Panorama Sunroof Glass

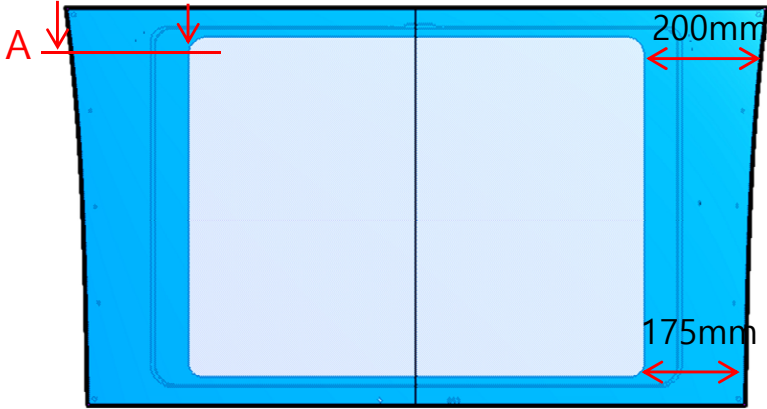
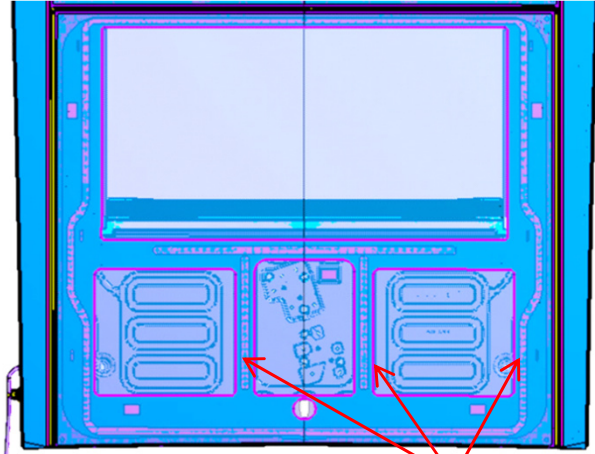
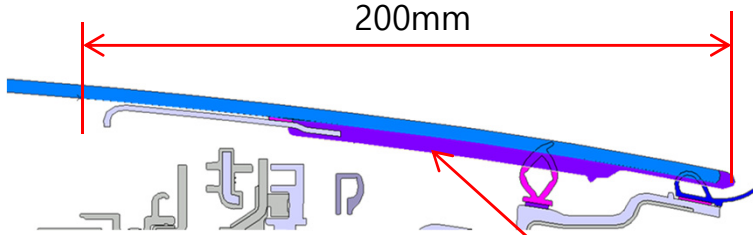
Item	Front Glass	Rear Glass
Geometry		 <p style="text-align: right;">Glass Sealer</p>
Problem	<p>- For the non side-molding glass, the elimination of ceramic coated area allow the sunlight penetration in PU area, and glass could be broken off.</p>  <p style="text-align: center;">Section A</p>	<p>- Glass sealers are applied to prevent the booming and rattle noise near the motor mounting part, the ceramic coated areas are need to protect the sealer from the sunlight.</p>
